INDIANA HARBOR BELT RAILROAD COMPANY

BULLETIN ORDER NO. S-8
Effective: 0600 Sunday November 7, 2021

November 5, 2021
General Orders in effect: 101

8. Kankakee Line, Special Instructions – MODIFIED 9/14/2021

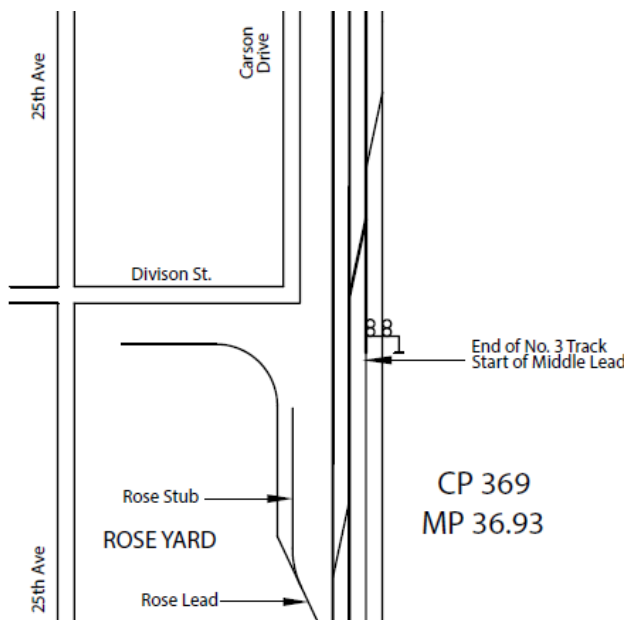
Effective 0600 9/14/2021, employees must make the following changes to the second bullet point under **SPECIAL INSTRUCTIONS** on page 7 of IHB Timetable No. 3. Strike through ~~CP GIBSON~~ and write in CP HOUSE. Foreign line crews must make the same changes to Page IHB-46 in the CORA guide. Below is how the second bullet point will read after the changes are made:

NO. 4 CONNECTING TRACK BETWEEN CP HOUSE AND CP 42: 10 MPH – RULE 6.28 IN EFFECT

16. DISPATCHER CHART – IHB MAIN LINE – REVISED 7/20/2021:

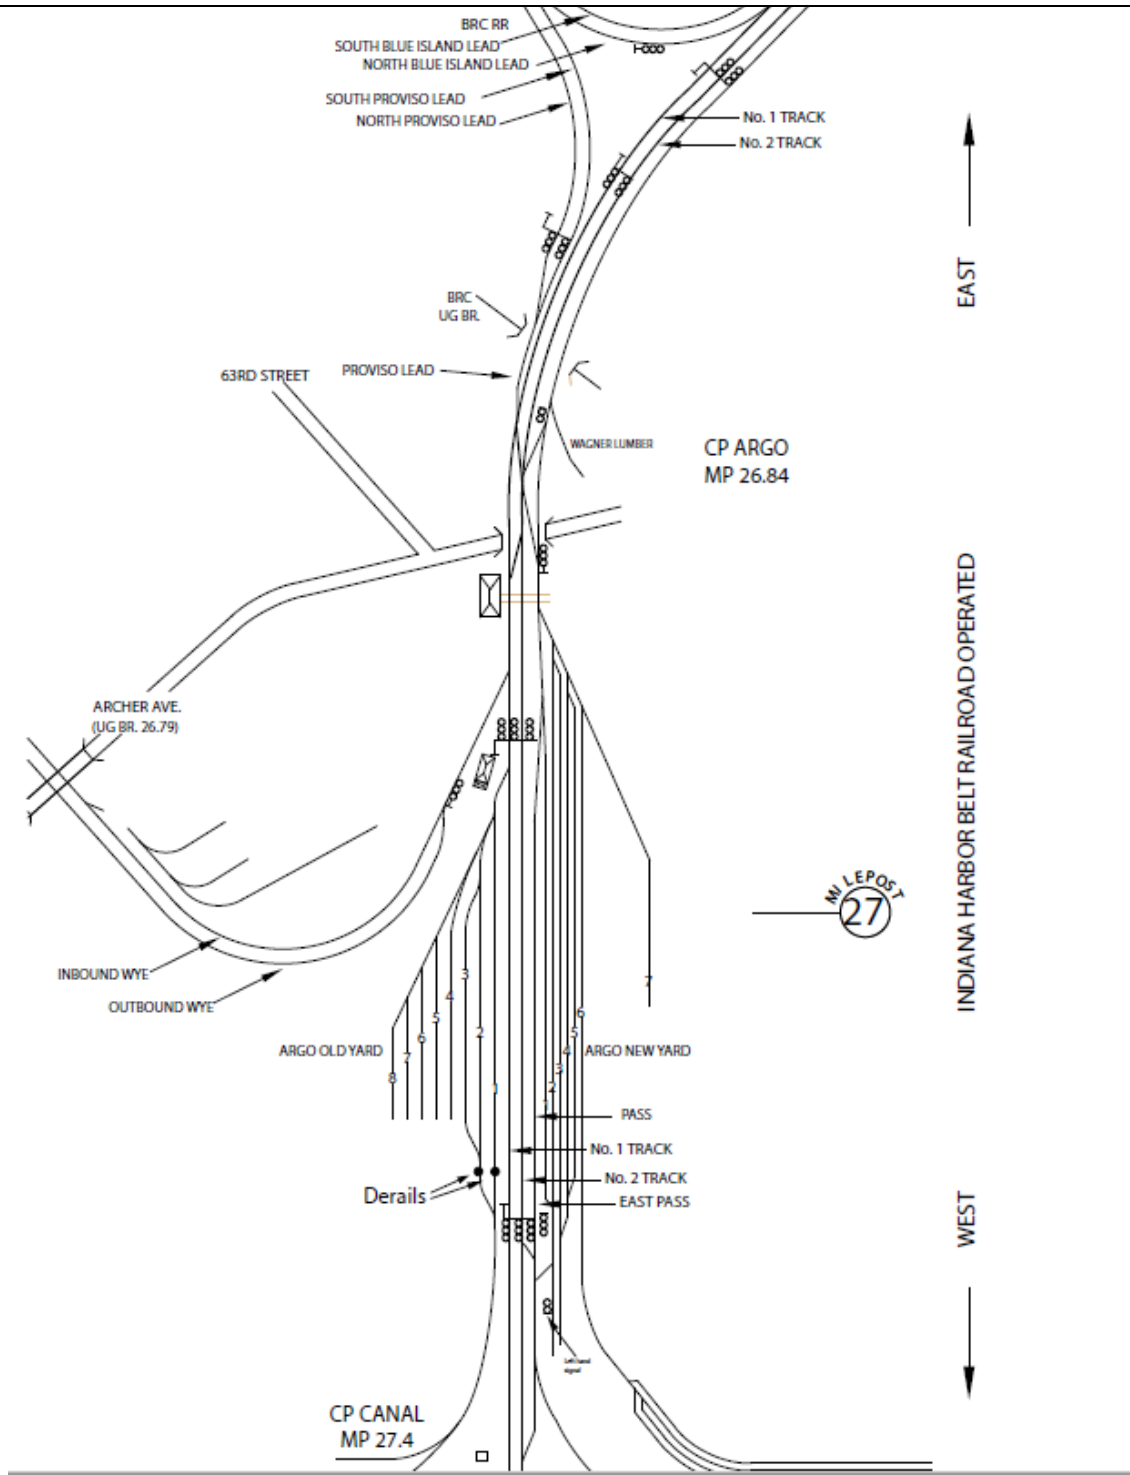
Effective 0600 7/20/2021, employees must make the following change to the Dispatcher Chart – IHB Main Line on page 16 of IHB Timetable No. 3. Foreign line crews must make the same change to page IHB-55 in the CORA Guide. Strike through ~~4,753~~ on the Dispatcher Chart – IHB Main line CP Argo to CP Canal on No.1 and No.2 main and write “1,113” in ink to revise the distance.

GIBSON AUTO YARD

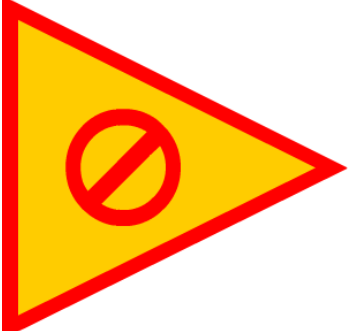
Effective 0600 7/16/2021, employees must add the sentences to the bottom of page 88 of IHB Timetable NO. 3, “In the Gibson Auto Yard, a job briefing must be held between the on duty Yardmaster any time there is a change to the securement of car(s) in track. Job briefing must be held by calling the West End Auto Yardmaster at 219-989-4827 or on radio channels 025-025 or 095-095. The Yardmaster will record this change on the securement form and brief with all applicable employees.” Foreign line crews must make the same change to page IHB-19 in the CORA guide. This change only applies to the Gibson Auto Yard, see example below:

In the Gibson Auto Yard a job briefing must be held between the employee and the on duty Yardmaster any time there is a change to the securement of car(s) in track. Job briefing must be held by calling the West End Auto Yardmaster at 219-989-4827 or on radio channels 025-025 or 095-095. The Yardmaster will record this on the securement form and brief with all applicable employees.

Q-1 Territorial Qualification of Train Service Employees

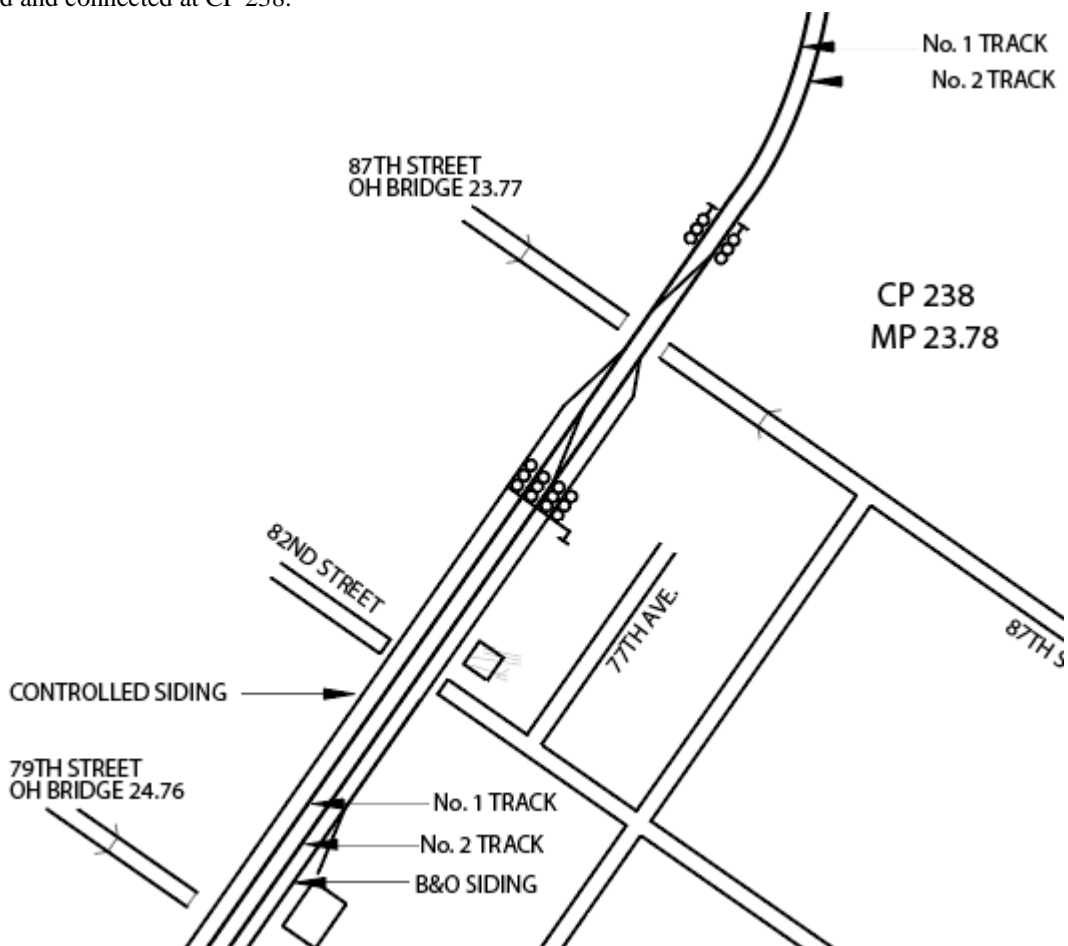
Effective 0600 7/7/2021, train service employees will be governed by the following. Locomotive Engineers qualifications for main track now will read “One Round Trip over the territory within the previous 24 months”. Train Service Employees must make changes below on page 2 of IHB Timetable NO. 3 and make a notation that the rule is changed in this notice. In the near future as sticker will be made available to make the modification to page 2.

- **Main Track** – One Round Trip over the territory within the previous **24** months.
- **Other Than Main Track** – Territorial familiarization briefing with qualified supervisor or engineer will be provided with an up-to-date job aid.
